INLAND FISHERIES AND WILDLIFE NATURE PARK - ADDENDUM #1

date: May 13, 2024
project: Inland Fisheries and Wildlife Store and Admin Office Project # 3096
prepared by: Ryan Kanteres Simons Architects
Adam Wiles-Rosell Simons Architects
Mikayla Molta Simons Architects

Subject: **Addendum #1** to Bid Documents of April 23, 2024

A401

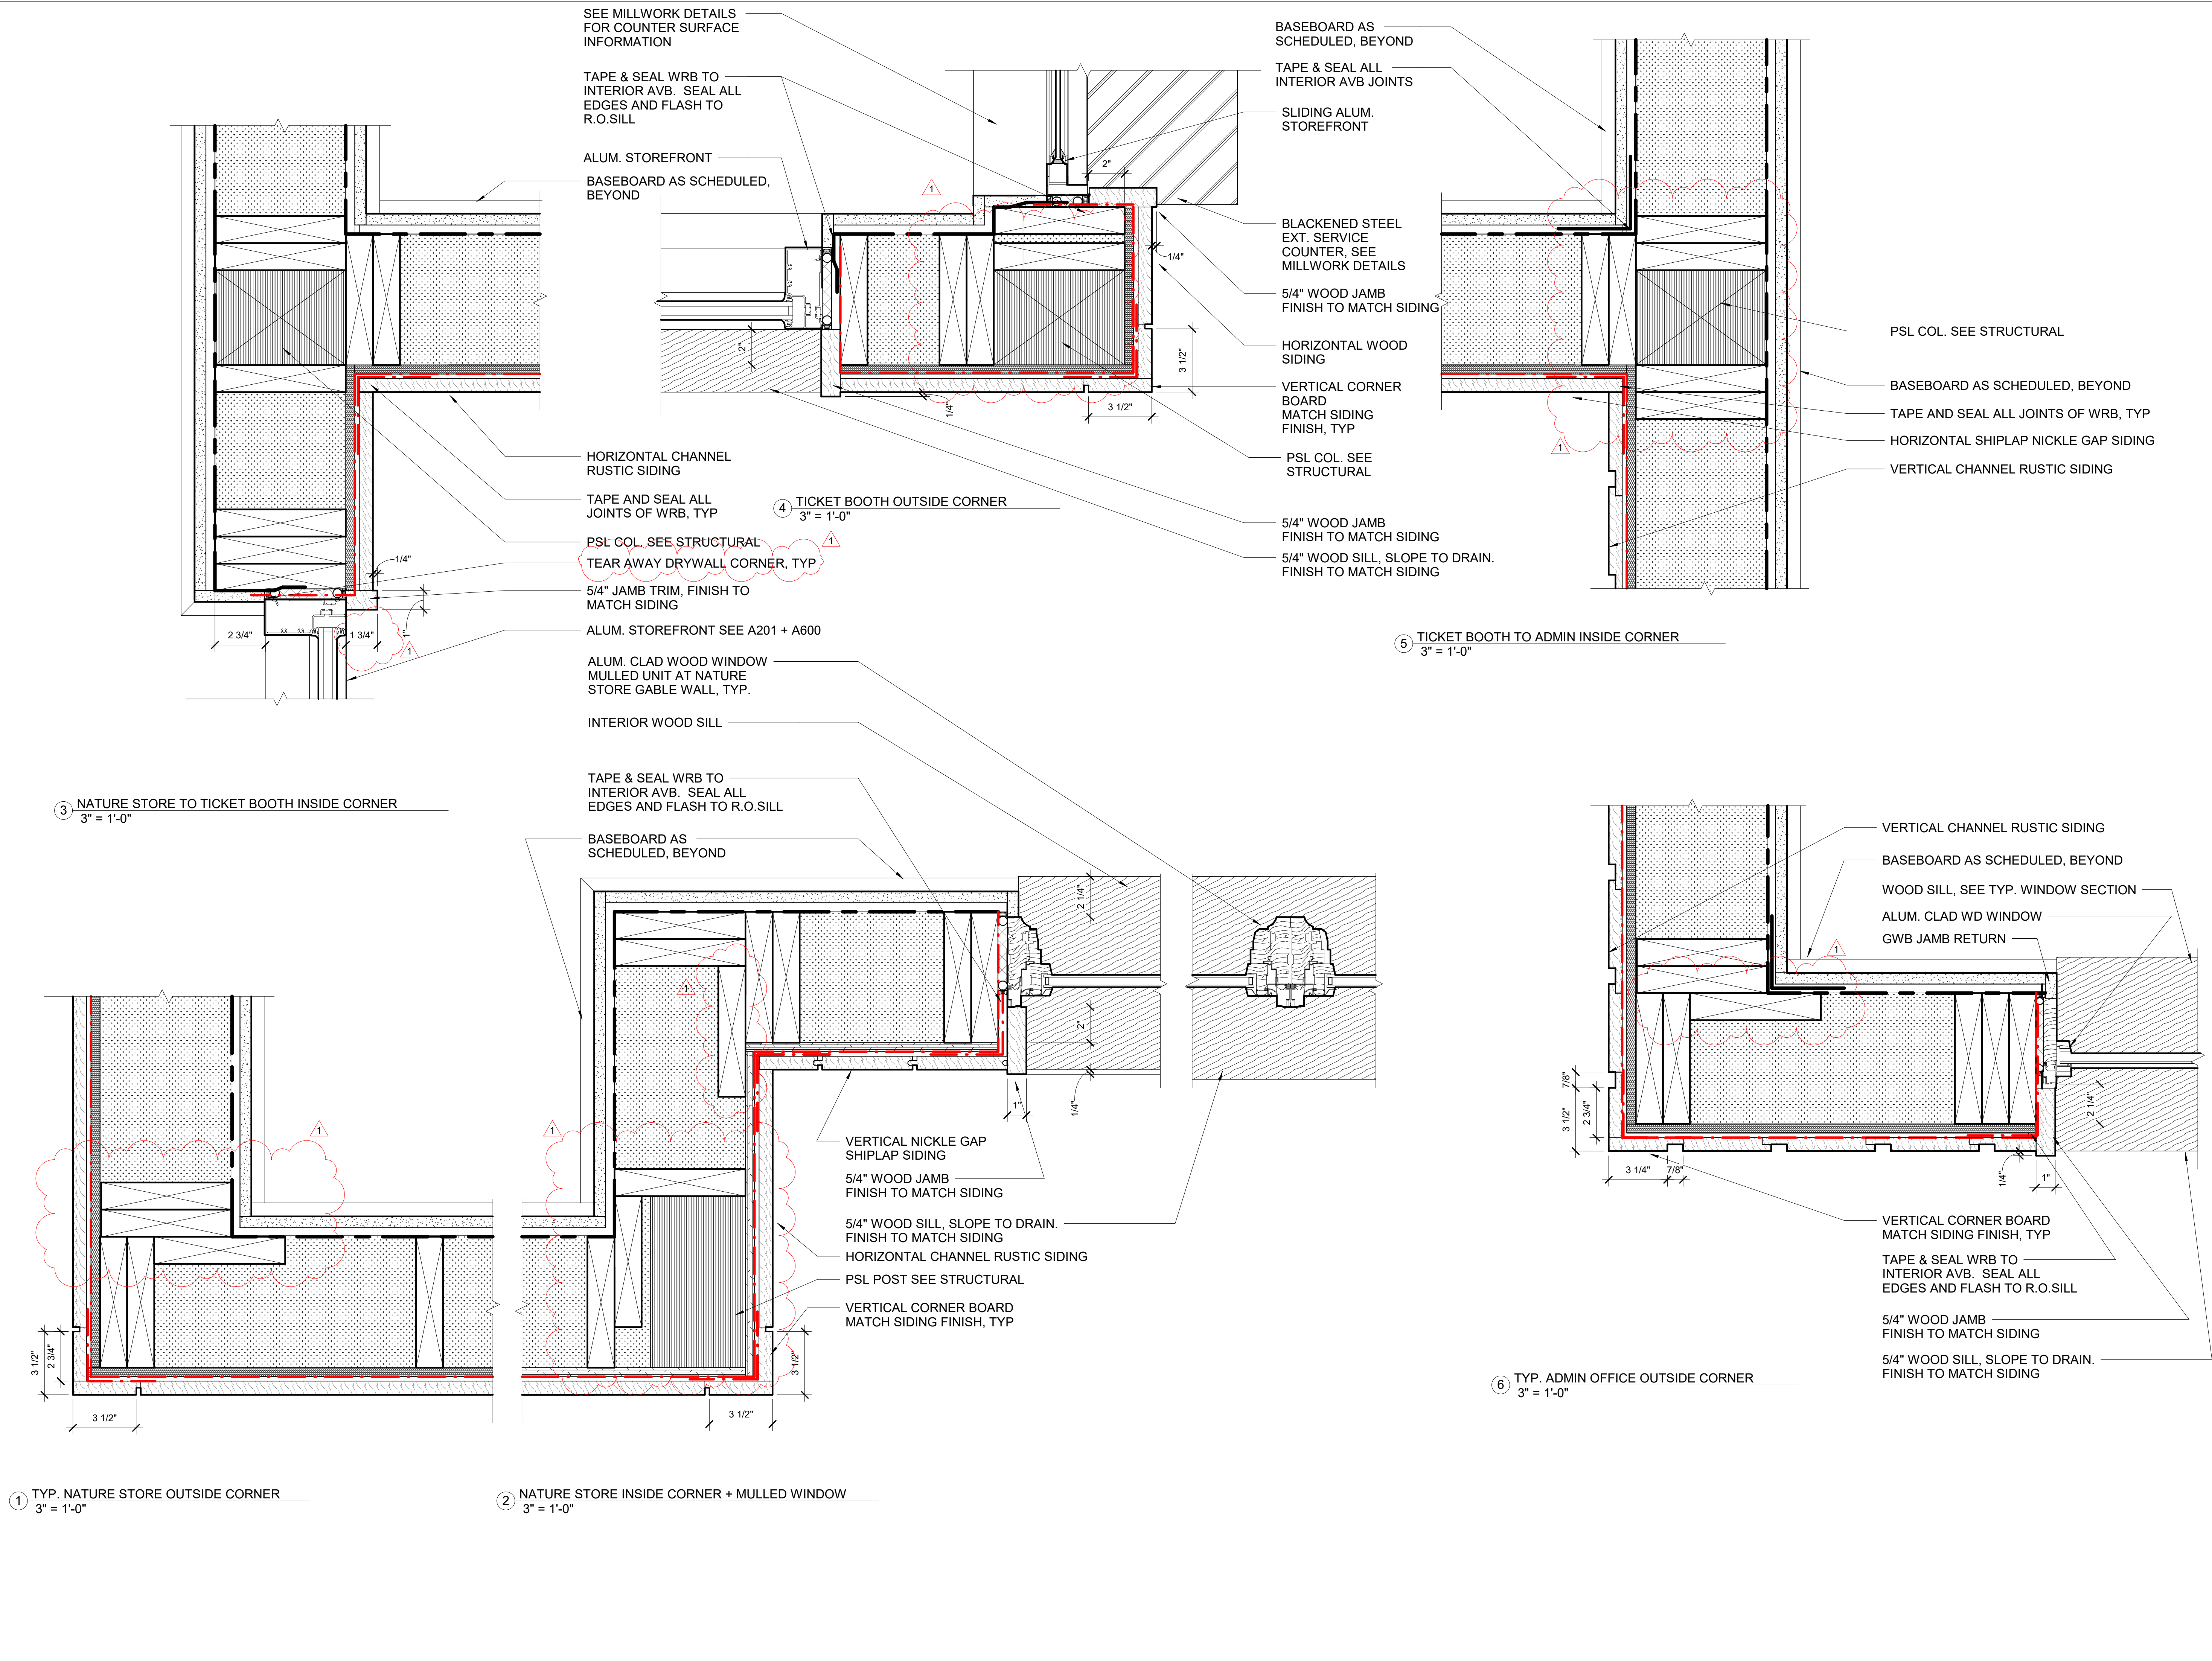
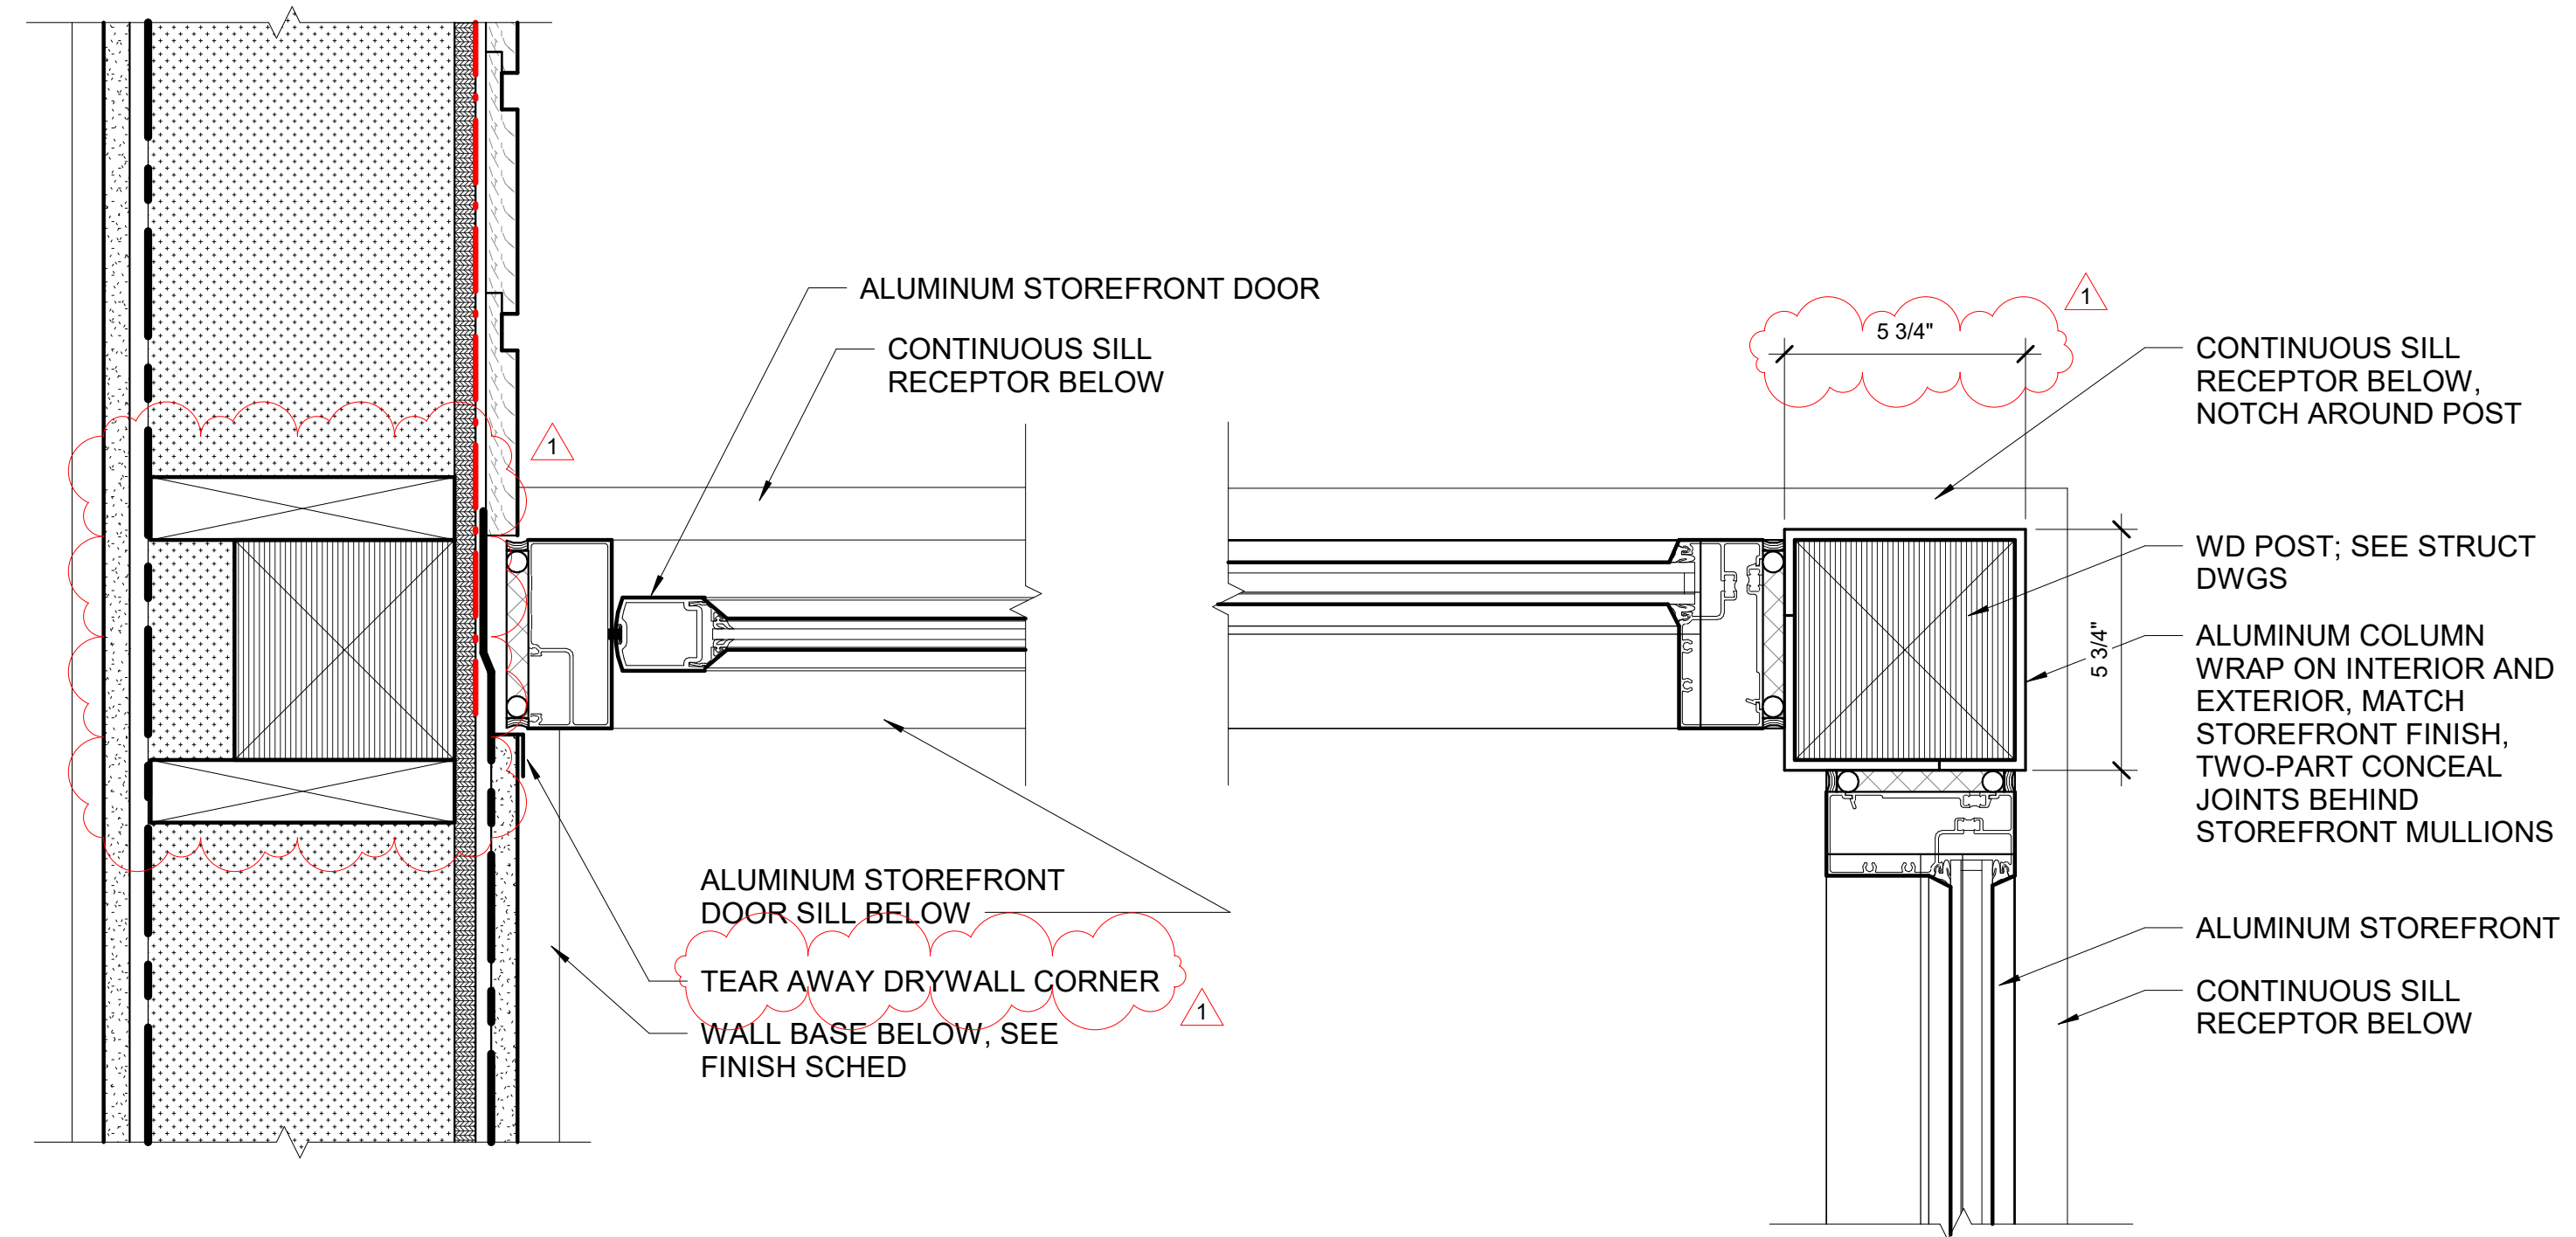
- 1-D17 Sheet A401 Coordinated post locations and sizes with structural drawings. Included 2x material for drywall fastenings and included tear away beads at window intersections. Adjusted door trim due to global 3/4" to 1/2" sheathing adjustment.
